# Architectural Review Board

Wednesday, September 24, 2025

## COhatch - Riverview Village 25-045AFDP

### Riverbank Decent

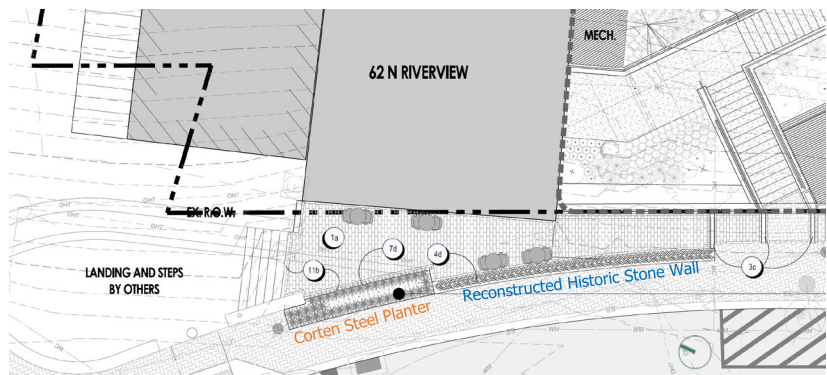
A preliminary design was presented during the FDP review for the area between the red cabin and the new building. The details have since evolved into a multifunctional design that accommodates service access to the middle level of the red cabin, ADA-compliant access

between the two buildings, a publicly-accessible patio, and connectivity to the future Riverside Crossing Park West paths and the historic ruins that will be maintained under the new building. The design includes a series of retaining walls and terraces, clad with a stone veneer. Two sets of stairs, placed at angles that maximize views of the Dublin Link bridge and the future park, are incorporated into the design. The set at the higher grade would consist of concrete steps with a stone-clad wall on each side. The bottom set would be closer to grade and consist of limestone steps and a stabilized crushed stone landing. All handrails and guardrails would be galvanized steel painted black with a design similar to that at the existing COhatch building. The flat surfaces forming the patio and service access would be paved with concrete.

A variety of landscape materials are proposed throughout the space and would also help screen mechanical equipment enclosures associated with the two buildings. They include deciduous and evergreen trees, flowering/deciduous shrubs, grasses, perennials, groundcovers, and vines. Stumps from some of the trees that were previously removed are also proposed to be incorporated into the space. LED tape lights are proposed to be incorporated into the stone caps along the stairs and patio, while LED uplights would highlight some of the stone walls and trees.

The overall design complements the setting and reinterprets in a creative way the historic terraces, steps and paths that historically extended between the red cabin and historic ruins.

## Plaza

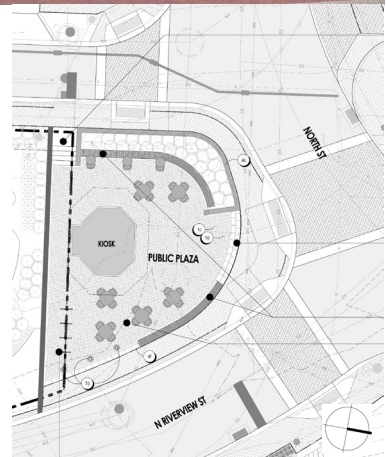
The overall design of the plaza at the north end of the site has remained the same, but some of the details have been enhanced. Refinements to the design of the surrounding streets have allowed the plaza to expand slightly to the west, creating a larger planting bed and more seating capacity. The stone walls on the north and south sides of the plaza now stairstep to provide more openness, while simultaneously offering protection/enclosure. Wood caps are proposed on several sections of the stone walls to accommodate additional seating. The steps leading into the plaza from the north have been widened to correspond to the width of a crosswalk that will link this space to the Dublin Link Bridge's West Plaza through a new path. A tree that was shown within the plaza at FDP has been removed due to conflicts with underground utilities, but an ornamental tree has been added to the widened planting bed.

There was uncertainty at the time of FDP approval as to whether the public streets were going to be paved with asphalt or brick pavers. For that reason, the applicant provided two paver color options for the plaza at that time. Given City Council's direction to use asphalt, the applicant is proposing dark red pavers consisting of an Endicott "Dark Ironspot" and "Medium Ironspot" blend.
